SERVICE BULLETIN	Bulletin No. 75-39 Date September 15, 1975 Page 1 of 3
SUBJECT: CLUTCH RATTLE ON TWIN CYLINDER MODELS		Read & Initial
Affected Models: ALL TWIN CYLINDER MODELS		Manager _____
Effective Engine No. _____		Parts _____
Reference: Page 44, T20 Service Manual		Service _____

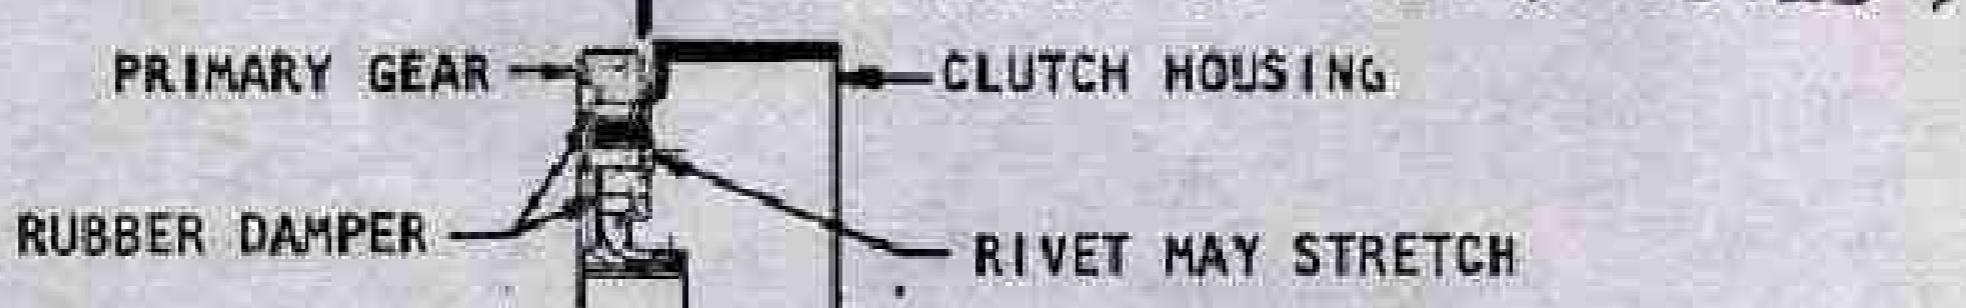
A. The clutch housing/primary gear is a riveted assembly. There are rubber dampers which cushion the drive shock between these two parts. If the rivets stretch or the dampers soften, the clutch housing will wobble and make the same noise. Try to separate the two parts with your hands.

There should be less than 1/32 inch play between the two parts. Don't try to tighten the rivets. Instead, replace the assembly.

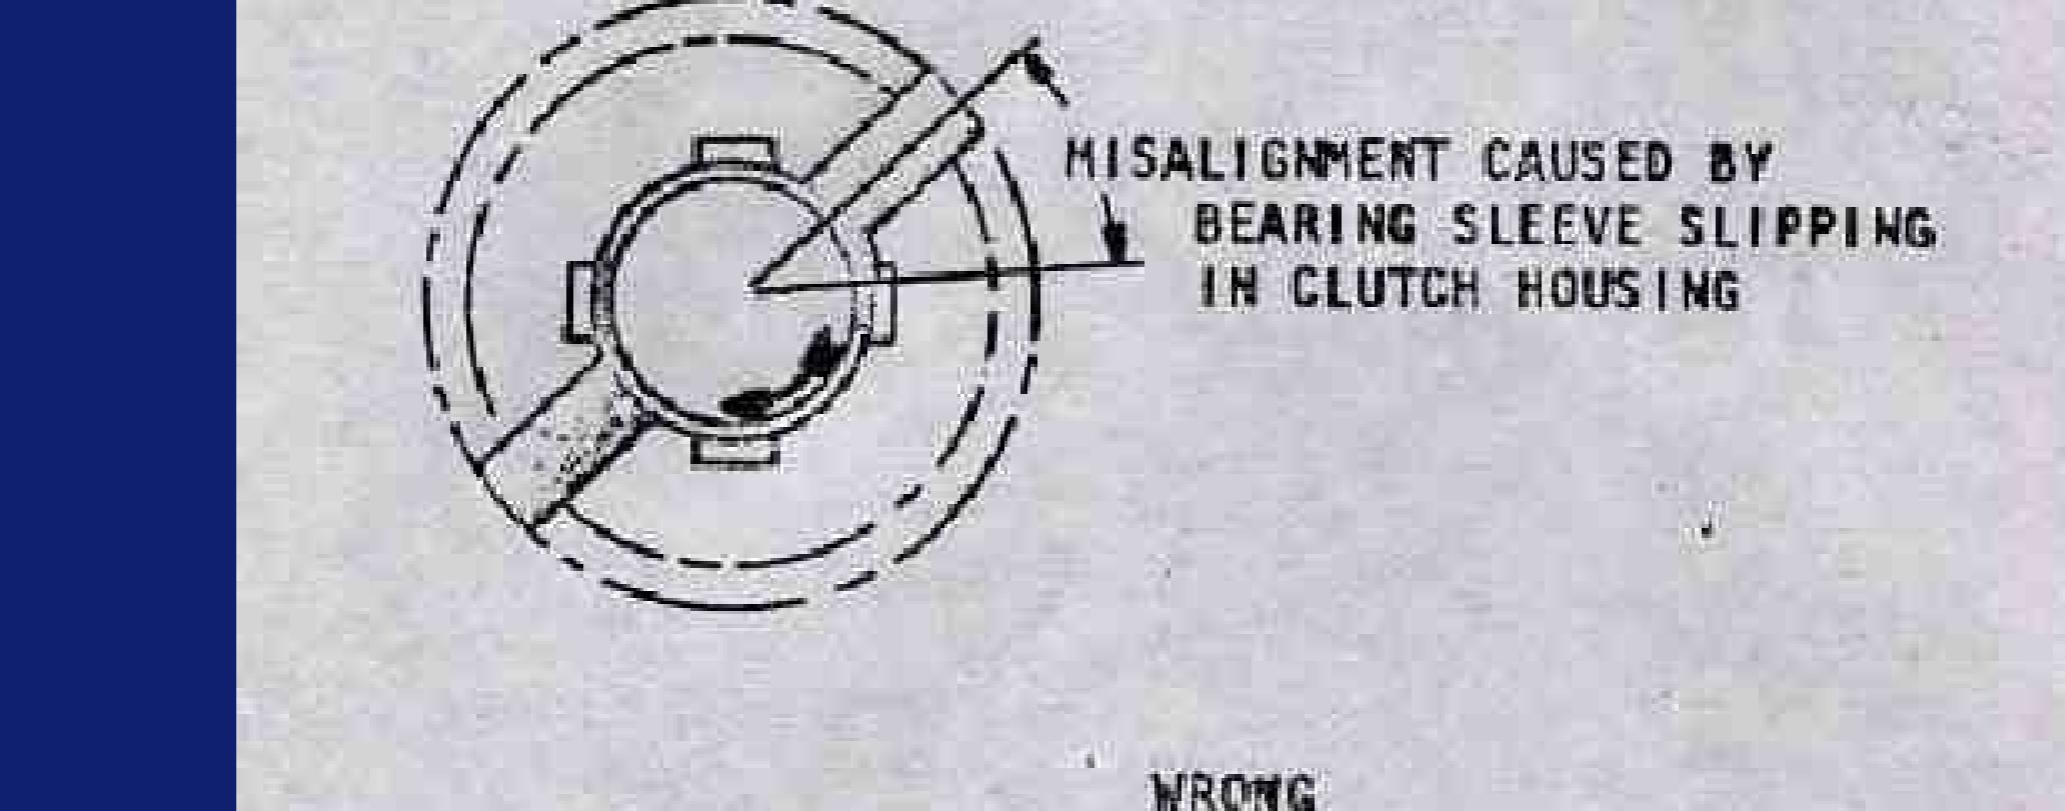
C. The X6, TC250, T200, TC200, T250, T305, TC305, T350, clutch housing is fitted with the kickstart drive gear on its backside. Be sure that the oil grooves in the gear are matched with the slots in the clutch bearing sleeve. Otherwise, the thrust face of the housing will prematurely wear due to lack of oil.

RIGHT
Slots Lined Up

WRONG
Gear Installed 90° off on Splines

WRONG
Bearing has seized on shaft, causing sleeve to slip in housing.

D. If the transmission oil level is too low, or if extreme heat is present in the clutch assembly, the clutch housing bearing will seize on the transmission driveshaft. The engine will stop suddenly, and the inertia of the rolling motorcycle will cause the clutch bearing sleeve, which is pressed into the housing, to spin in the housing. After it frees up, the clutch will work well. However, the thrust surface of the clutch housing will starve for oil and wear too quickly, again causing this "rattling" noise.
